13 Derby Lodge
6.12.2016

CF_127_REP_161206_RevisedScheme

1. Introduction

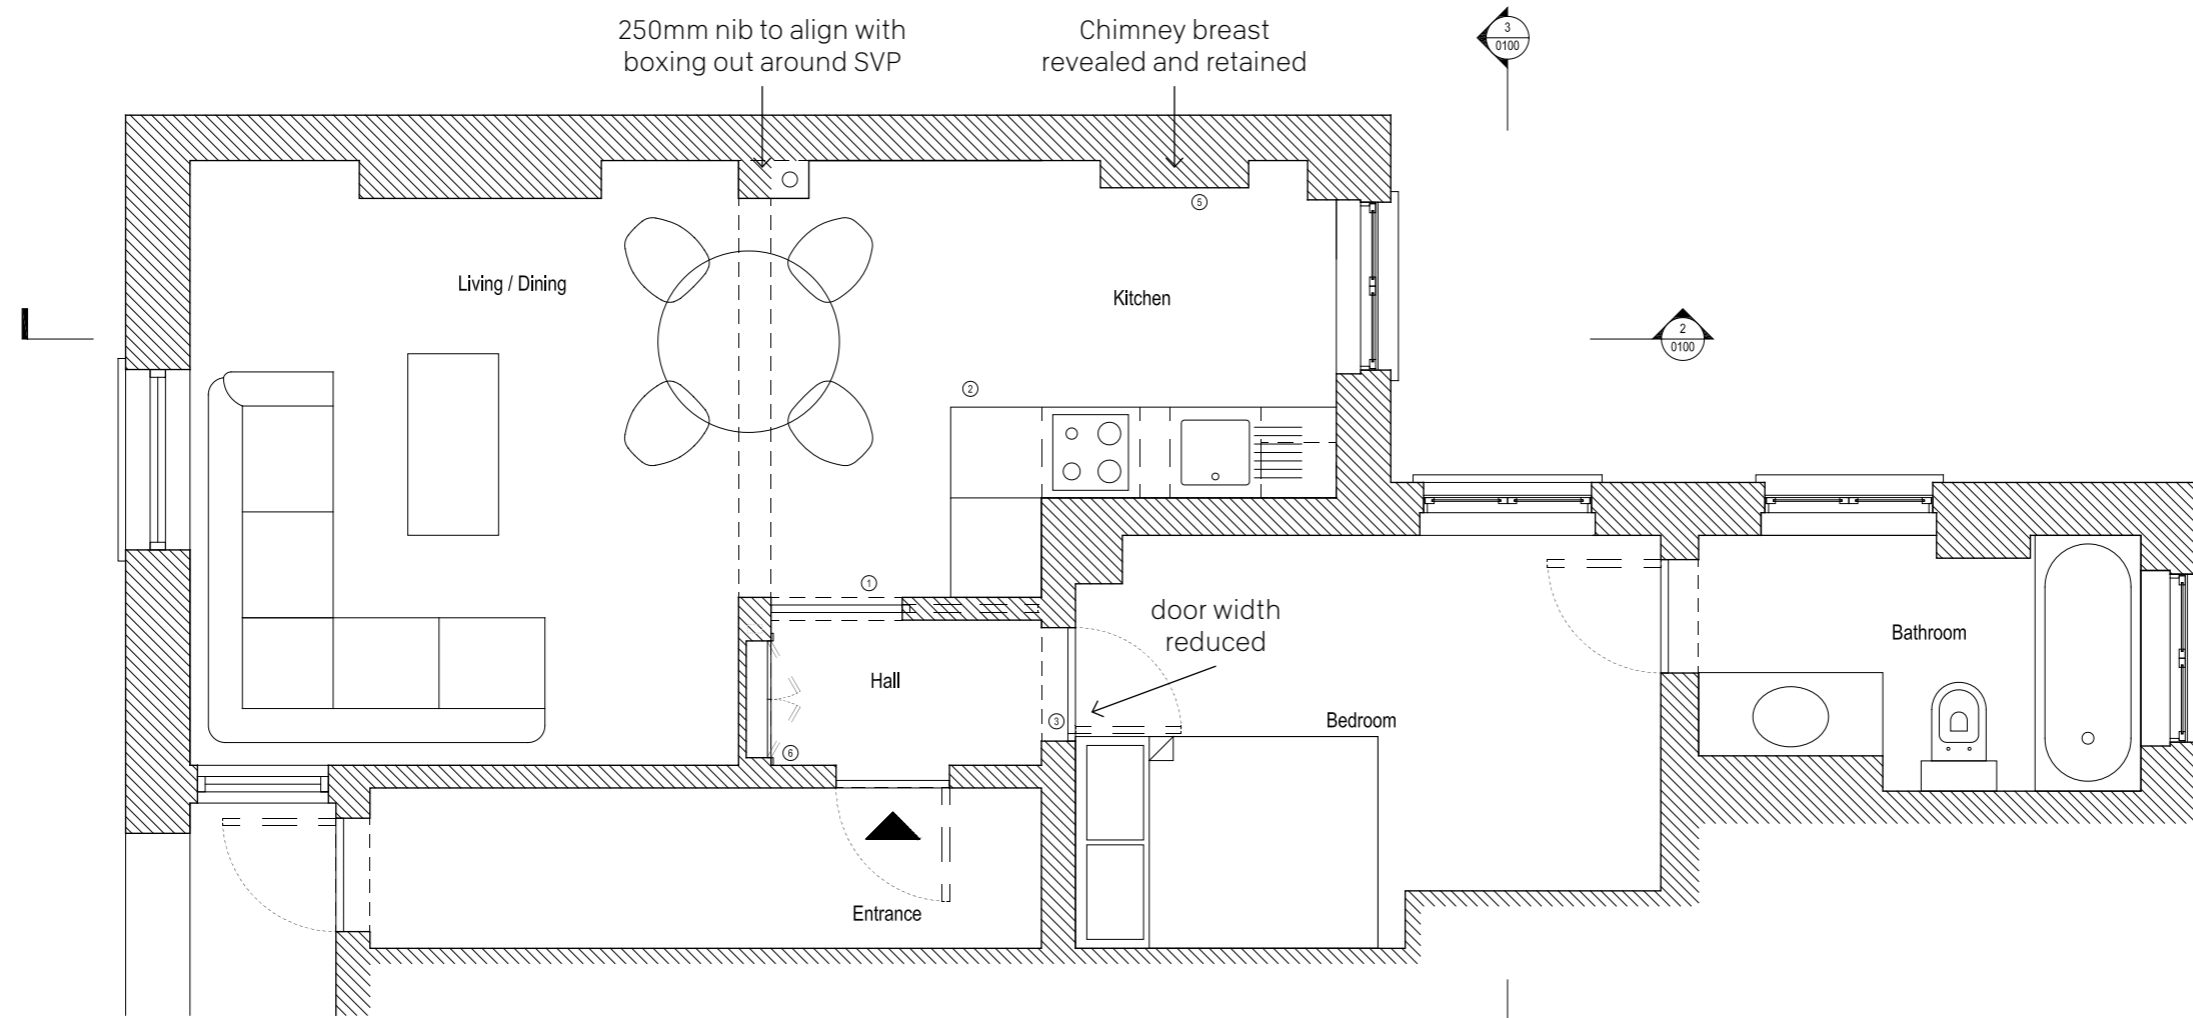
1. Removal of non-original kitchen linings to reveal chimney geometry
 - Further investigation to be carried out to determine geometry of concealed wall and location of assumed chimney breast.
2. Existing architraves should be retained around the doorway which is proposed to be closed up.
 - To retain memory of original door and layout
3. Reduction in the width of the proposed down stand beam
 - Beam should reflect width of existing partition wall.
 - 200mm deep down stand suggested
4. Proposed opening between kitchen and living room.
 - Additional existing fabric should be retained to maintain readable memory of original layout.
 - Proposed opening should be articulated as an opening within the existing wall.

Regarding point 1, similar flats above and below the applicants property have been visited. The flat above retains the original chimney arrangement. This geometry has been surveyed to understand the size and location of the chimney breast running up this wall of Derby Lodge. This survey information has been incorporated in the revised existing and proposed drawings.

1 PLAN PROPOSED

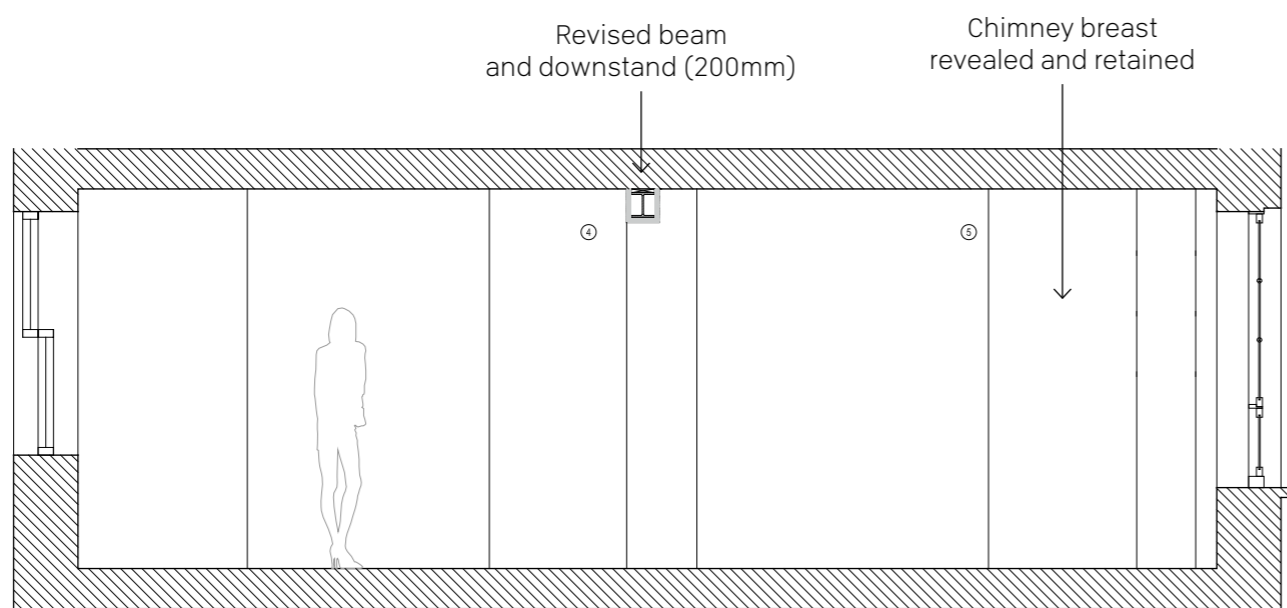
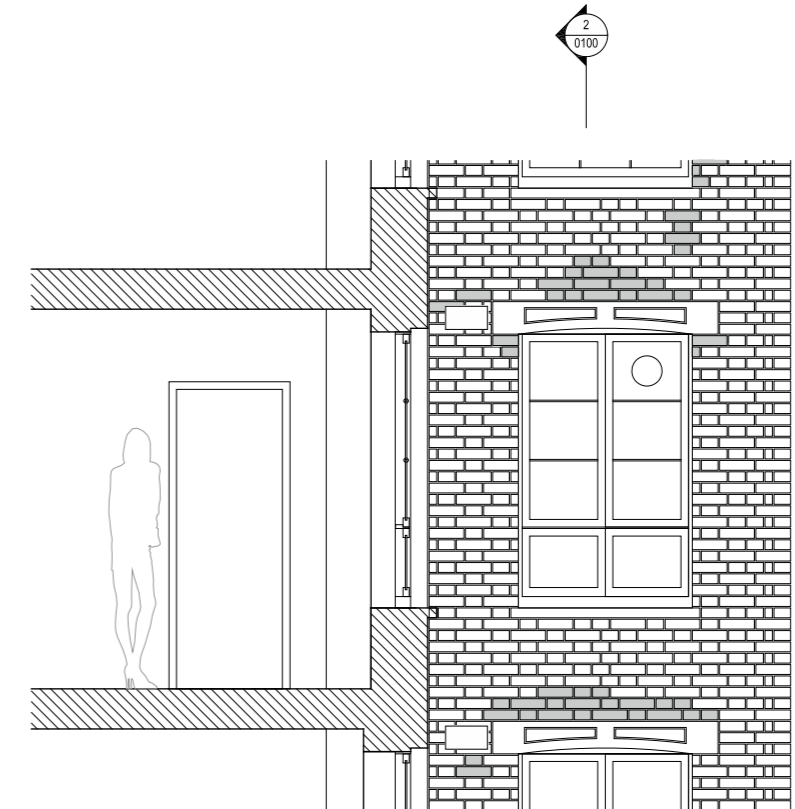
During recent dialogue the council first suggested that a nib of 450mm be retained on the chimney breast side of the existing wall. In this scenario the council were content for the other side of the opening to align with the edge of the partition surrounding the existing entrance hall. A 450mm nib would render this part of the room impossible to furnish as a dining area. In response the applicant has proposed a nib of 250mm which would align with the depth of the existing chimney breasts. The nib would also align with boxing out surrounding the existing soil pipe. In response to this suggestion the council have accepted the proposal of a 250mm rather than 450mm deep nib however they have requested the addition of a further 250mm nib on the opposing side. The opening would therefore no longer align with the edge of the entrance hall but would project a further 250mm into the proposed room. This projection would serve to severely compromise the proposed layout and the intention to use this central area for a table. As such the applicant is not willing to incorporate this additional nib as part of their proposals.

The applicant has accepted the first three of the council's suggestions, outlined above, and incorporated them within the revised proposals.

The applicant hopes that the proposal to incorporate a 250mm nib on the chimney breast side of the proposed opening can be considered an acceptable compromise between their wishes and the wishes of the council.

- A down stand beam of 250mm is proposed
- A nib of 250mm on the chimney breast side of the wall is retained
- On the opposing side of the opening a significant length of original wall is retained (1.1m)
- The architrave surrounding the existing doorway will be retained to further articulate the history of the original wall.
- The gap between the retained architrave and the edge of the proposed opening of 250mm creates a balanced elevational composition in relation to the 250mm nib on the opposing side.
- Overall 40% of the original wall will be retained
